MEMO No. 5

RE: **Hillview Crossing TED Conditional Use – Block Length & Pedestrian Pathways**

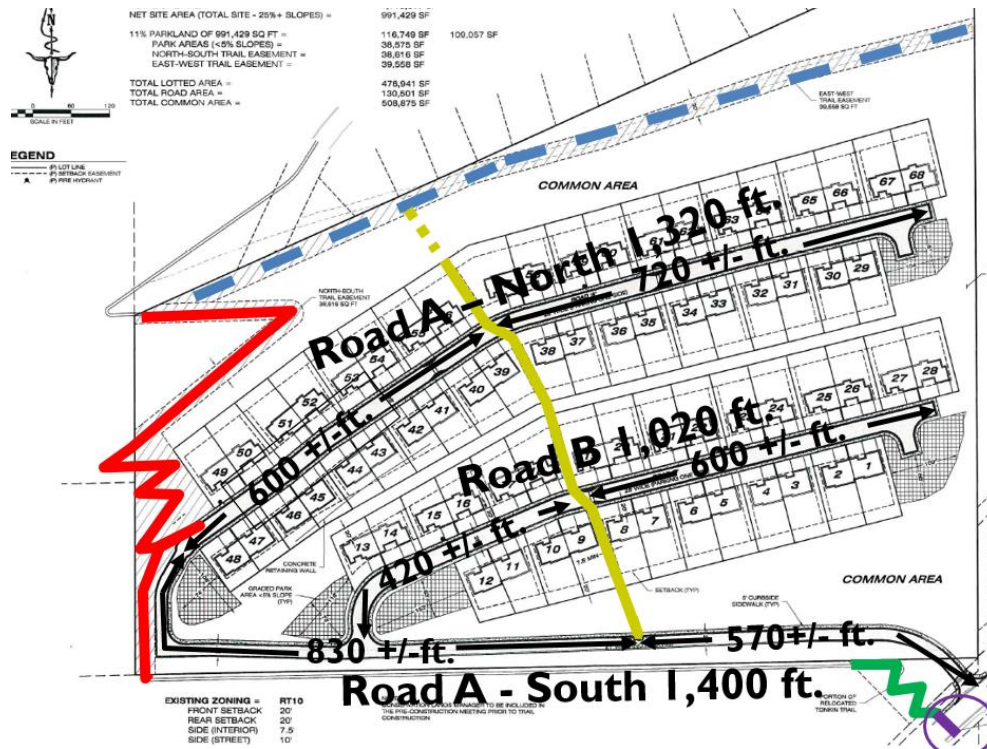
All of the roads greatly exceed the 480 foot maximum block length.

- Road A – South is approximately 1,400 linear feet or +/- 0.26 miles
- Road A – North is approximately 1,320 linear feet or +/- 0.25 miles
- Road B is approximately 1,020 linear feet or +/- 0.19 miles

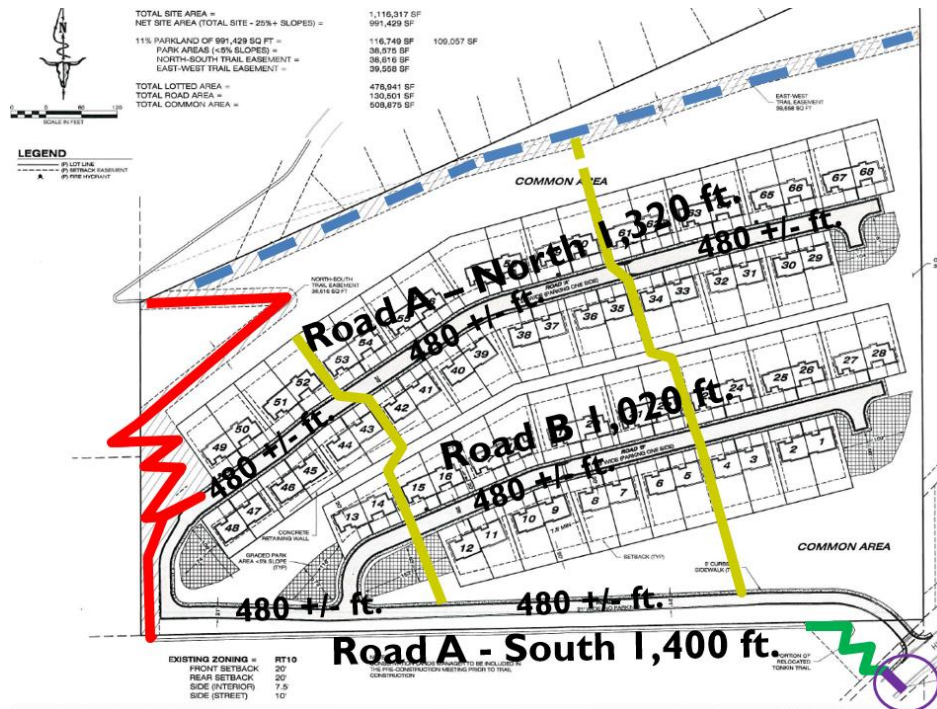
1. Road “A” south is approximately 1,400 linear feet (over one-quarter mile). Road “A” north is approximately 1,320 linear feet (one-quarter mile). Road “B” is approximately 1,020 linear feet (one-fifth mile).

2. Without the pathway/stairs required in Condition of approval #9, a pedestrian starting out from the eastern end of the northern segment of Road “A” has to walk approximately one half mile to reach Hillview Way.

3. Without the pathway/stairs required in Condition of approval #9, a pedestrian starting from the eastern end of Road “B” has to walk approximately just under one half mile to get to Hillview Way.

9. The applicant shall dedicate a minimum 20-foot wide easement and construct a paved pedestrian pathway/stairs from southern segment of Road "A" through the common area extending between unit ownership parcel numbers 8 and 9, crossing Road "B" then continuing between unit ownership parcel number 18 and 19, crossing the common area and extending between unit ownership parcels 38 and 39, crossing the northern segment of Road "A" then continuing between unit ownership parcel number 56 and 57. An easement for future trail improvements shall be dedicated from northern parcel boundaries of unit ownership parcel numbers 56 & 57 northward through the common area and connecting to the east-west trail easement near the northern property line of the TED. Plans for the pedestrian pathway/stairs shall be reviewed and approved by Development Services prior to zoning compliance approval of the townhome exemption declaration. Improvements shall be installed prior to building permit approval of the first structure or included in an Improvements Agreement guaranteed by a security, subject to review and approval by Development Services.

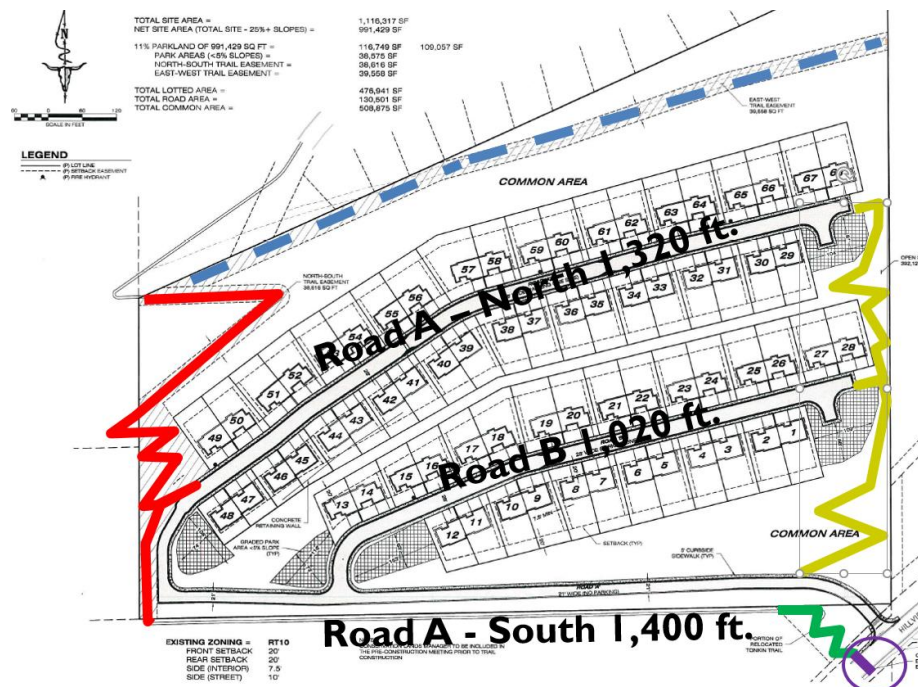
2. Road “A” south is approximately 1,400 linear feet (over one-quarter mile). Road “A” north is approximately 1,320 linear feet (one-quarter mile). Road “B” is approximately 1,020 linear feet (one-fifth mile).

3. Without the pathway/stairs required in amended condition of approval #9, a pedestrian starting out from the eastern end of the northern segment of Road “A” has to walk approximately one half mile to reach Hillview Way.

4. Without the pathway/stairs required in amended condition of approval #9, a pedestrian starting from the eastern end of Road “B” has to walk approximately just under one half mile to get to Hillview Way.

9. The applicant shall amend the site plan to dedicate two (2) 20-foot wide minimum pedestrian easements and construct a paved pedestrian pathway/stairs from southern segment of Road "A" through to Road "B", crossing Road "B" then continuing through to the northern segment of Road "A", crossing the northern segment of Road "A" then continuing between TED ownership units to the common area north of the northern segment of Road "A" in the locations shown on Exhibit A (see above), such that the pedestrian pathway/stairs are approximately 480 feet apart. An easement for future trail improvements shall be dedicated from northern TED ownership unit boundary of the easternmost pedestrian pathway/stairs northward through the common area and connecting to the east-west trail easement near the northern property line of the TED. Plans for the pedestrian pathways/stairs shall be reviewed and approved by Development Services prior to zoning compliance approval of the townhome exemption declaration. Improvements shall be installed prior to building permit approval of the first structure or included in an Improvements Agreement guaranteed by a security, subject to review and approval by Development Services.
